SUPPLEMENTARY ECOLOGY NOTE – USKMOUTH POWER STATION CONVERSION PROJECT

This file note has been prepared to respond to ecological comments in the NRW consultation letter dated 9 July 2020 (reference: CAS-123618-F8L7) which relate to the Uskmouth Power Station B Conversion Project; Planning application reference: 20/0748. The letter has been structured to respond to each of the specific comments made by NRW, focussing in particular on the location and nature of the main construction activity within the site. Clarifications are provided in turn in relation to; otter habitats, water voles, wintering birds, breeding birds and fish. An Outline Water Vole Conservation Strategy has also been prepared for the Uskmouth Conversion Project which is provided alongside this letter.

Figure 2: Illustrative Dark Corridors - Development Area and Railway Line

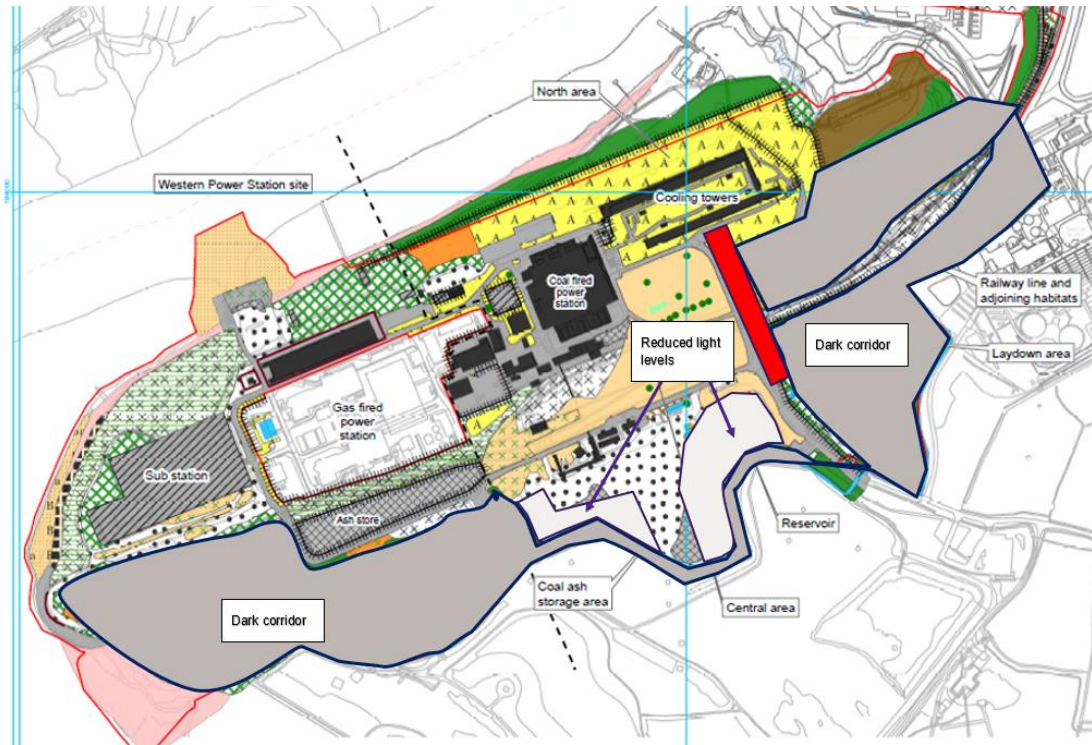
The dark corridor plan for the development area and land adjoining the railway line is provided as Figure 2. This shows the extent of the dark corridors around the proposed development area and along the green

corridor connections to Julian's Pill. Figure 3 shows the dark corridors around the power station in their wider landscape context.

The dark corridor will also be maintained during operations. There are three existing 10m floodlights positioned on the southern boundary of the coal stockyard adjacent to the western boundary ditch. Although currently not working, historically the boundary ditch would have been subject to significant light spill from these floodlights. The commitment to ensuring the southern boundary is a dark corridor will make a permanent improvement in comparison to the former lighting strategy at the site.

The existing lighting will be subject to full review prior to the development of the detailed lighting design. Where required existing units will be updated with the use of modern lighting specifications including LEDs, which will minimise light spill within and around the lit parts of the development and ensure that the dark context of boundary green infrastructure and adjoining designated sites is protected. The existing railway line will continue to be used for deliveries to the power station and lighting of the tracks will need to be re-established for operational reasons. Modern lighting specifications will be adopted with LED lighting units to be installed focusing light into the operational line with negligible back lighting and sharp cut off.

Western Boundary Ditch – Located in close proximity to the southernmost silo, the lighting statement defines how the detailed lighting scheme will retain the whole of the western boundary ditch as a dark corridor with lux levels at a maximum of 0.5 lux at the ditch.

Figure 2- Noise modelling – Boiler House Silo

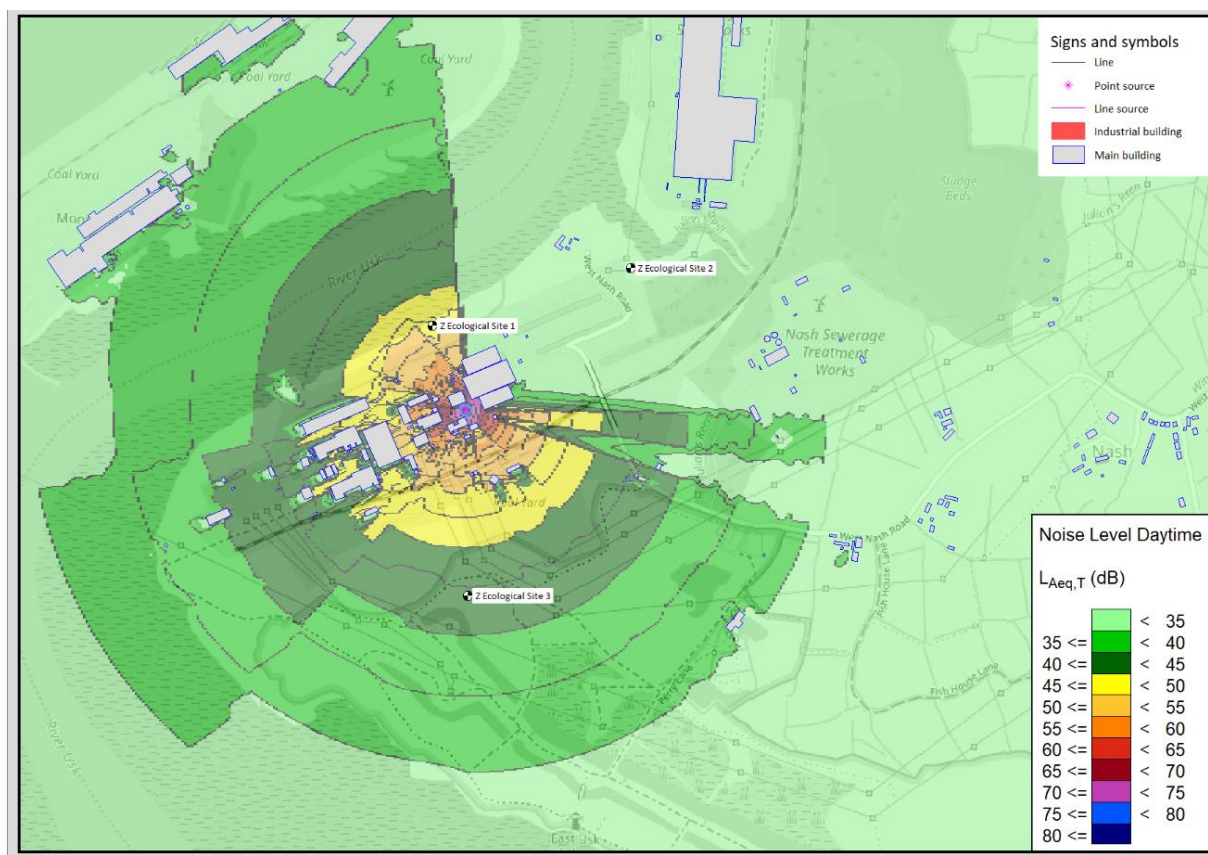
The noise modelling for the auger piling confirms that elevated noise above 55dB is very localised around the point of piling activity as illustrated on Figure 2. At this piling location closest to the River Usk, areas subject to 55dB and higher are located entirely within the site, around the main power station buildings and infrastructure, with a very small proportion of the intertidal habitat located within the 40dB to 50dB zones.

Noise levels below 55dB would not alter the behaviour of wildfowl using waterbodies in the Newport Wetlands. At these low levels of noise there would be no impact on wintering bird species utilising intertidal habitat during the periods of piling.

Although the boundary of the power station landholding extends up to the intertidal zone the actual locations of the construction activity have a very significant separation from the River Usk. Noise modelling at the closest piling location to the estuary (Figure 2) graphically demonstrates the limited levels of noise travelling through air on the boundary of the River Usk. There is no piling or other noise generating activity in the river

and the potential for transfer of noise from air to water is very low. Piling in terrestrial areas over 160m from the closest intertidal habitat will result in a negligible level of noise within the main channel of the River Usk with no potential for any impact on migratory fish.
